ALERT SERVICE BULLETIN
Bell Helicopter **TEXTRON**

NO. 206-06-110

SUBJECT: UPPER LEFT-HAND TAILBOOM ATTACHMENT
HARDWARE, INSPECTION OF

HELICOPTERS AFFECTED: All Model 206A/B helicopters serial number 4 through 4449 and model TH-67 helicopters 5101 through 5237 that had a 407-030-750-103 upper left-hand CRES steel fitting field retrofitted.

Figure 1: Tailboom Attachment

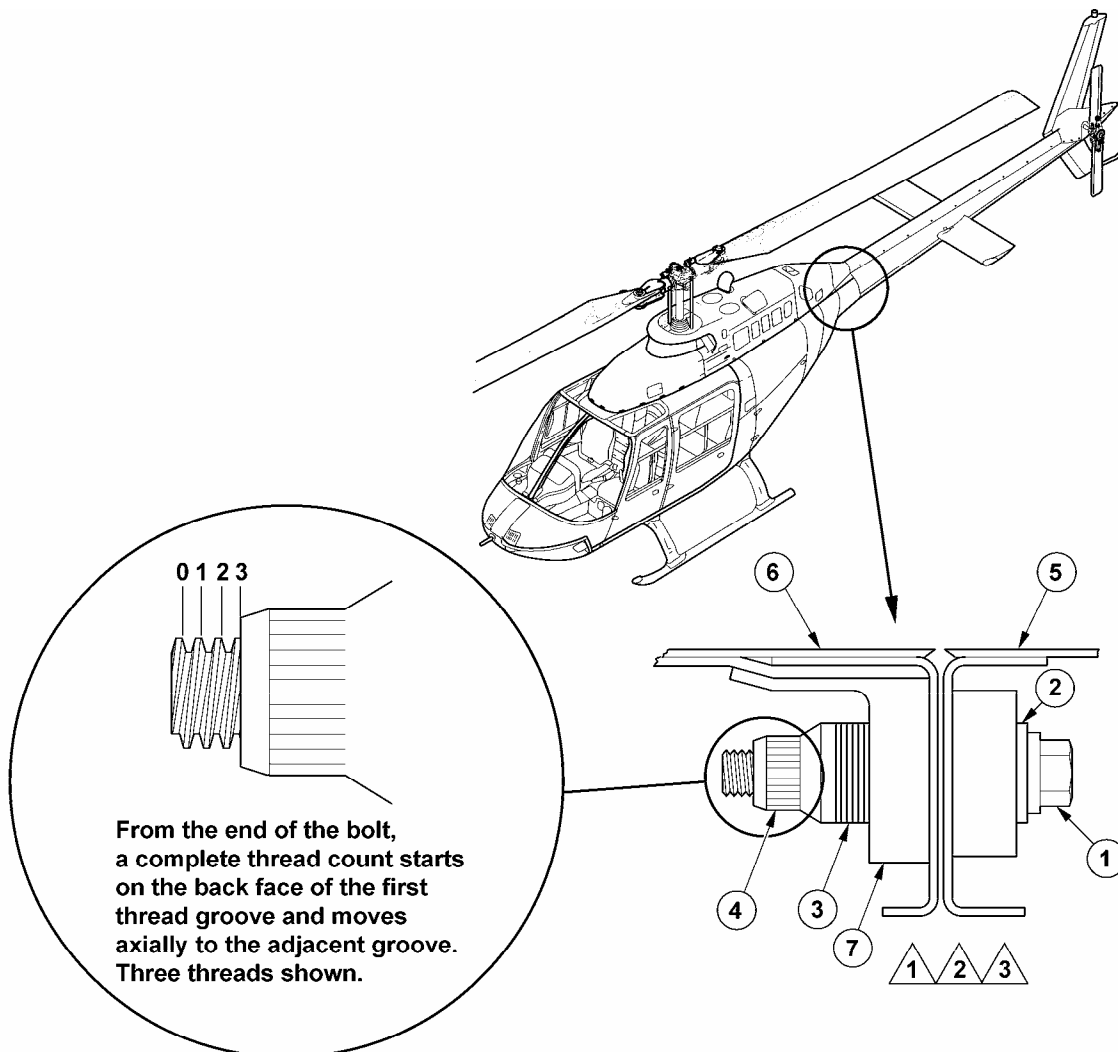
5. For helicopters affected by this bulletin that have a CRES fitting installed, perform thread count on the upper left hand attachment bolt (1) as per Figure 1.

6. If the correct amount of thread is exposed (between 1 and 3), do a torque check. Refer to the Maintenance Manual. If the torque is correct, make an entry in the helicopter records to indicate that this bulletin has been accomplished. If the torque is found below minimum and a replacement bolt (1) is not available at this time, adjust the washer (3) quantity as required per Figure 1. Refer to the Maintenance Manual and torque as required. Make an entry in the helicopter records to indicate that the PART I of this bulletin have been accomplished and that the PART II of this bulletin will require accomplishment.

7. If less than 1 thread is exposed, adjust the washer (3) quantity as required per Figure 1. Refer to the Maintenance Manual and torque as required. Make an entry in the helicopter records to indicate that this bulletin has been accomplished.

8. If more than 3 threads are exposed and a replacement bolt (1) is not available at this time, adjust the washer (3) quantity as required per Figure 1. Refer to the Maintenance Manual and torque as required. Make an entry in the helicopter records to indicate that the PART I of this bulletin have been accomplished and that the PART II of this bulletin will require accomplishment.

9. If more than 3 threads are exposed and a replacement bolt (1) is available, accomplish PART II of this bulletin.

1. Remove and discard the upper left hand tailboom attachment bolt (1, Figure 1). Install new bolt (1) and adjust the quantity of washer (3) as required to ensure correct installation as shown on Figure 1. If serviceable, the nut (4) does not require replacement. Refer to Maintenance Manual.
2. 100 hours after installation, do a torque check of the upper left hand tailboom attaching hardware (BHT-206A/B-SERIES-MM).
3. Make an entry in the helicopter records to indicate that this bulletin has been accomplished.

- 1 Bolt (1) and chamfered washer (2) are to be installed through tailboom (5) and Aft fuselage (6). Bolt head and chamfered washer are to be installed on the tailboom side. Steel washers (3) are to be installed next to fitting (7) to provide not less than one thread and not more than three threads exposed on threaded end of bolt (1).
- 2 If thread count is less than one, remove washers as required.
- 3 If thread count is more than three, remove and replace bolt, then readjust number of washers to meet requirement of note 1.
